ADDRESS: 252 QUINCE ST

Proposal: Legalize as-built roof and dormers

Review Requested: Final Approval

OVERVIEW: This application proposes to legalize the as-built roof and dormers at 252 Quince Street, which deviate from the plans approved by the Historical Commission in December 2023. Deviations from the approved plans include the removal of original roof and framing, removal of front and rear cornices, construction of a roof above the location of the original roof, and installation of new dormers that differ in proportions from the approved dormers. This application for legalization was prompted by a staff site visit and subsequent issuance of a violation by the Department of Licenses and Inspections for construction that exceeded the approved plans. The Historical Commission reviewed the application at its meeting on 8 November 2024 and remanded it back to the Architectural Committee for a new review. The Commissioners suggested that their primary concern was the alignment of the cornices with those of the neighboring buildings.

A-201 EXTERIOR ELEVATIONS
 DANIELLE HARVEY
 252 QUINCE ST.
 PHILADELPHIA PA 19107
 11/18/2024

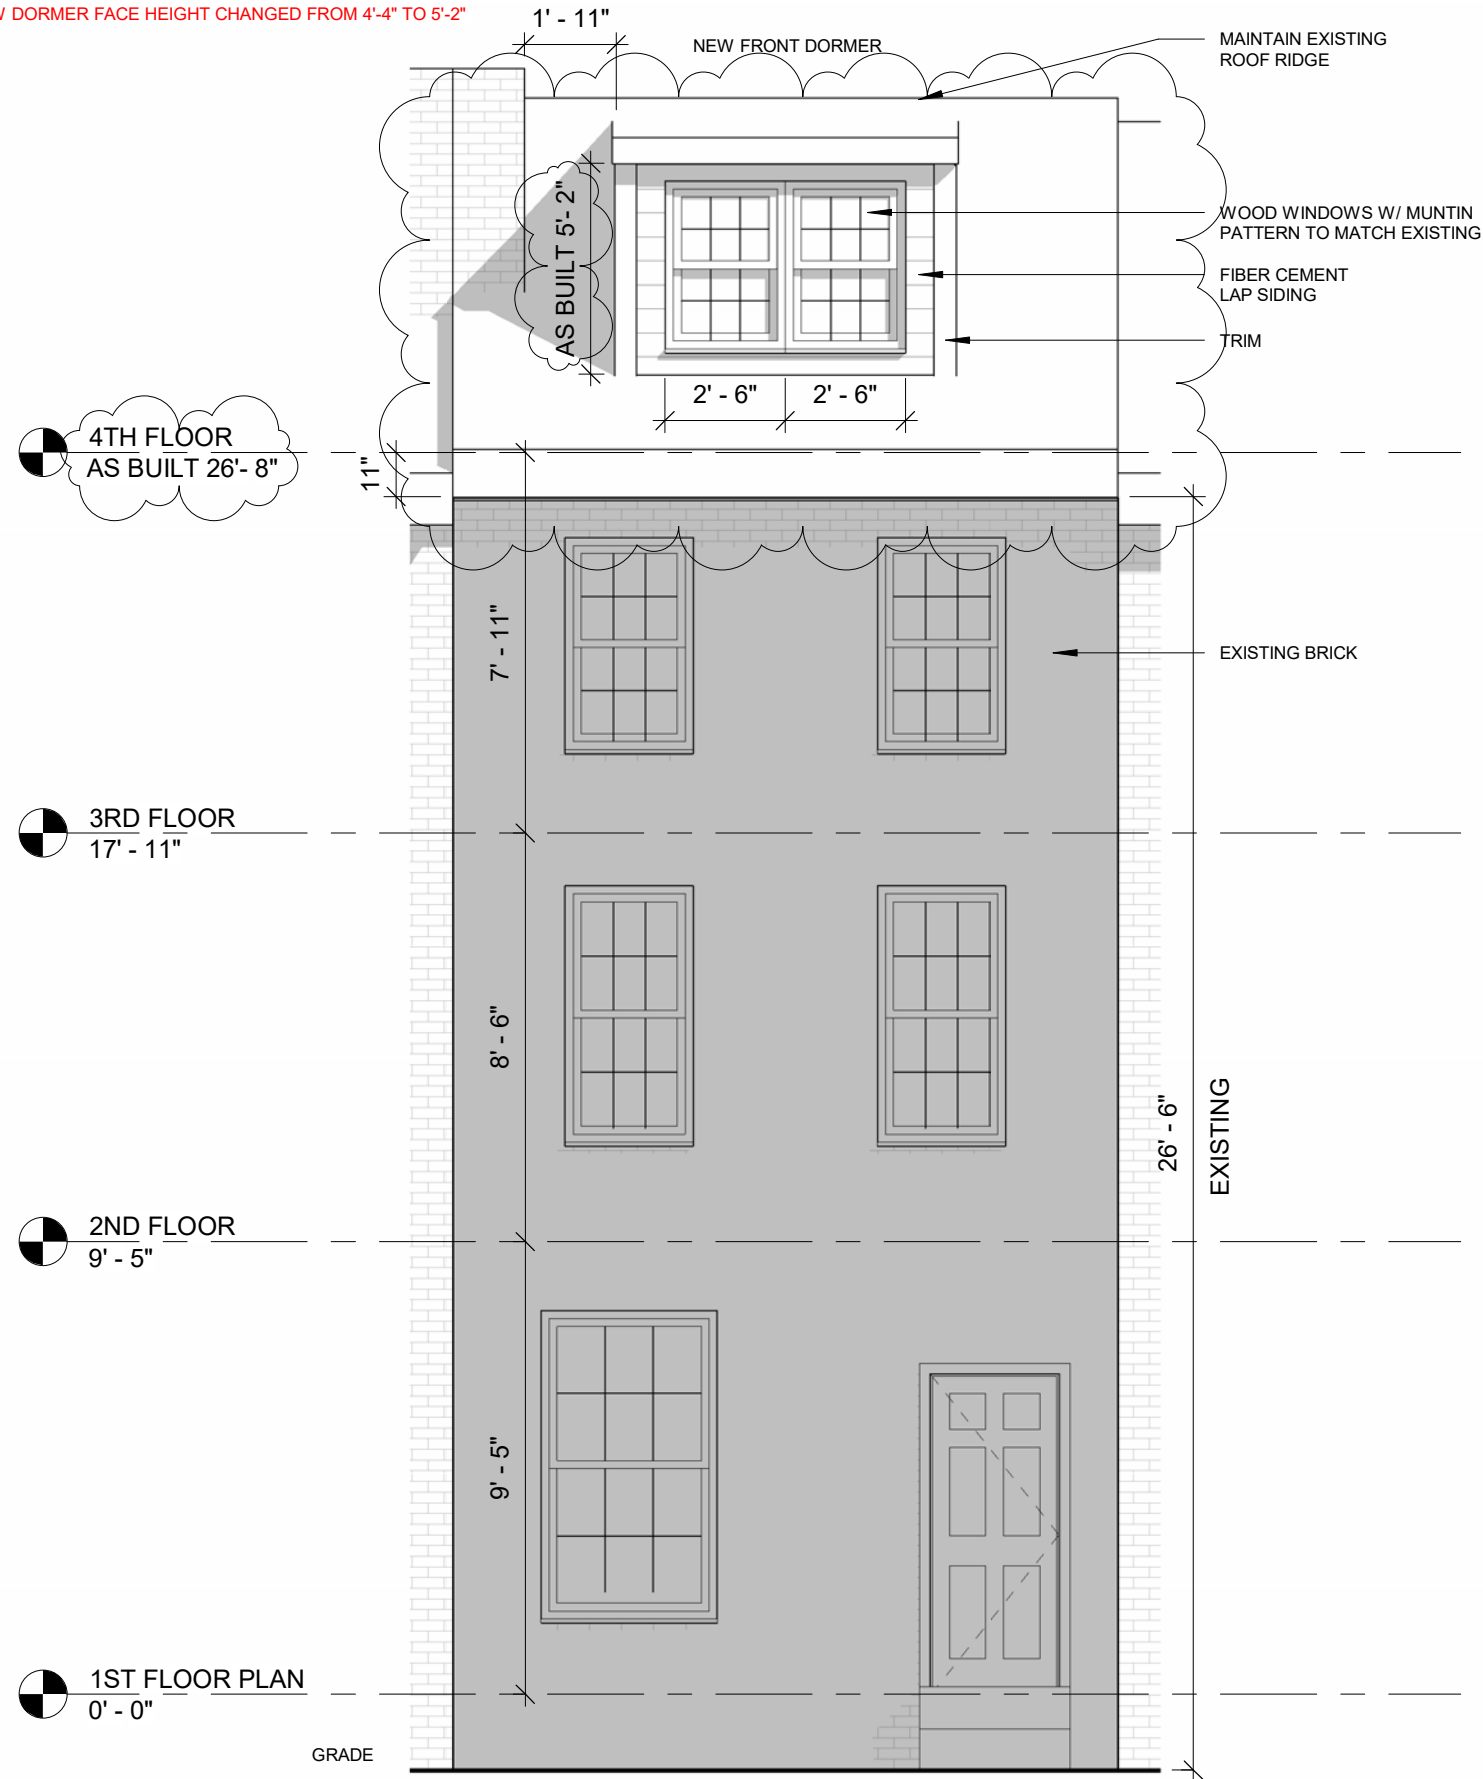
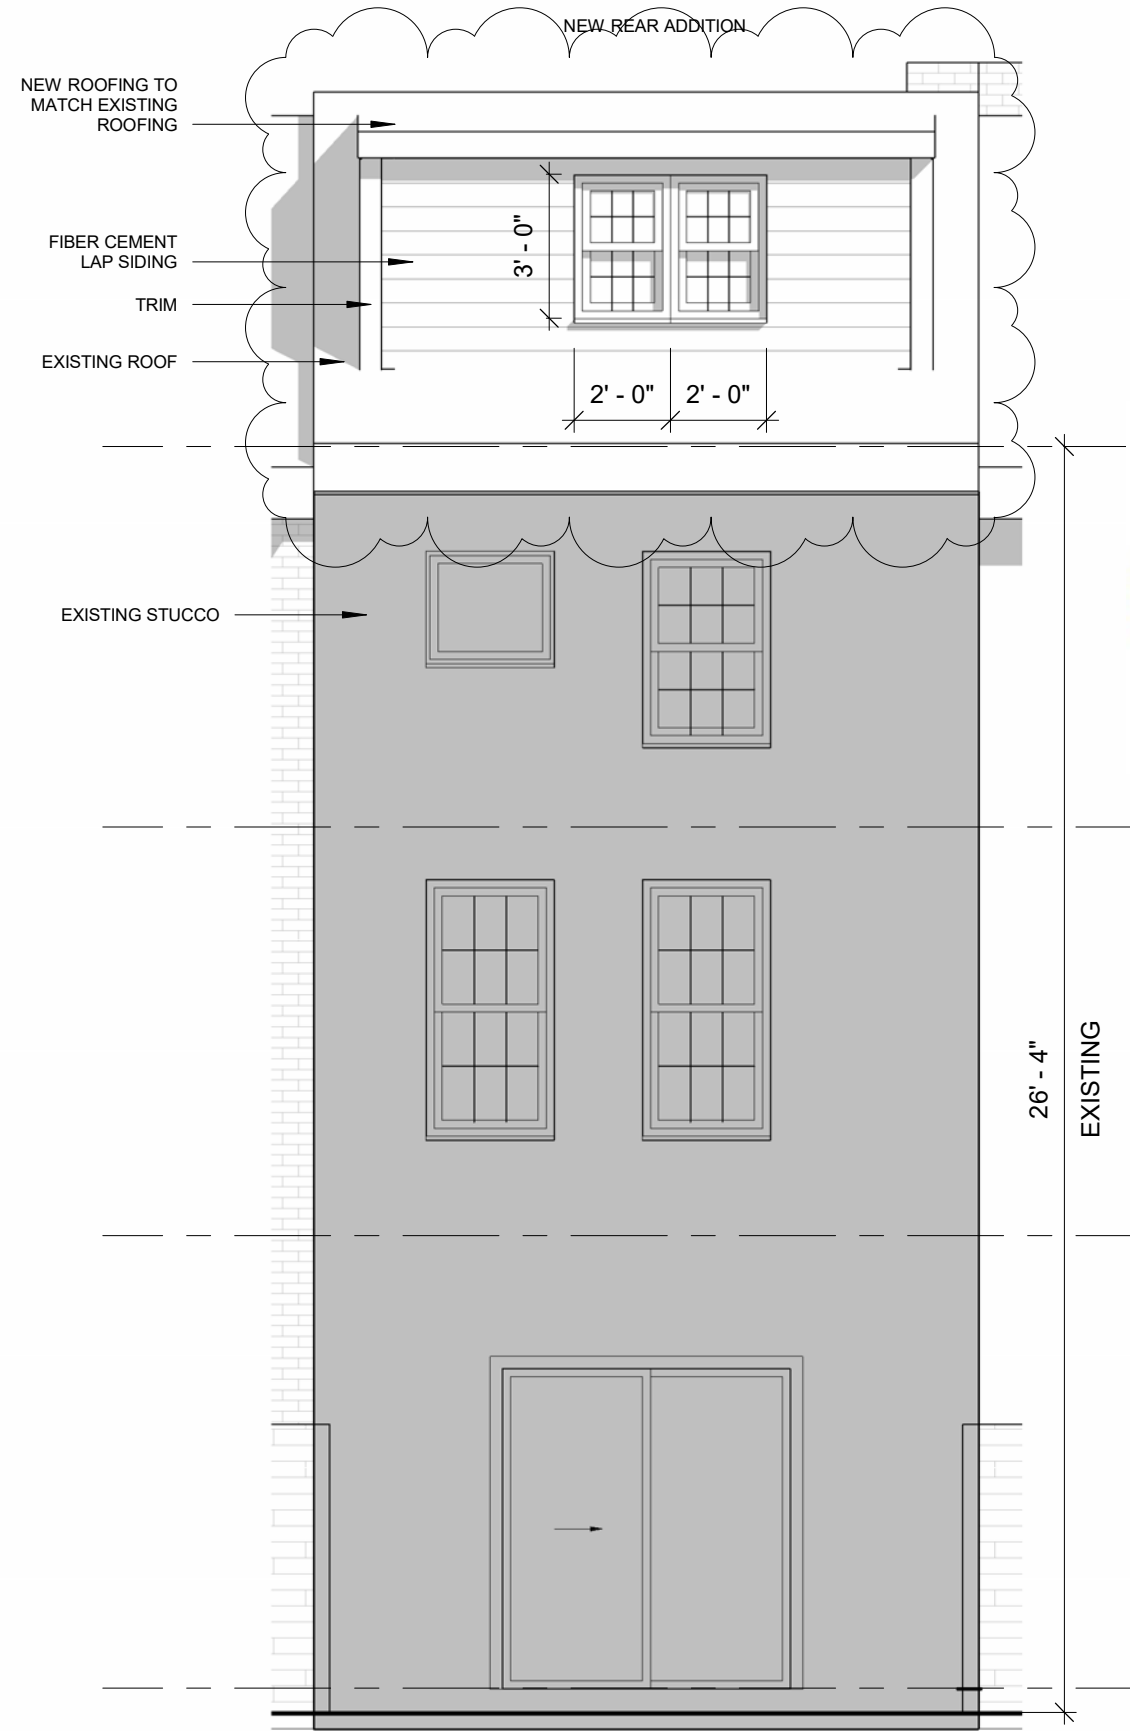
- The gable roof, which was constructed above the location of the historic roof, and dormers, which were constructed taller than approved, are incompatible with the historic property and environment and fail to satisfy Standard 9.

- Front and rear dormers were constructed 10 inches taller than approved plans and the dormer cornices are oversized. As currently constructed, the dormers are highly visible from the public right-of-way and fail to satisfy the roof guideline.

STAFF RECOMMENDATION: Approval, provided the cornices align with those of the neighboring buildings, as suggested by the Historical Commission, pursuant to Standards 9 and 10, and the Roofs Guideline.
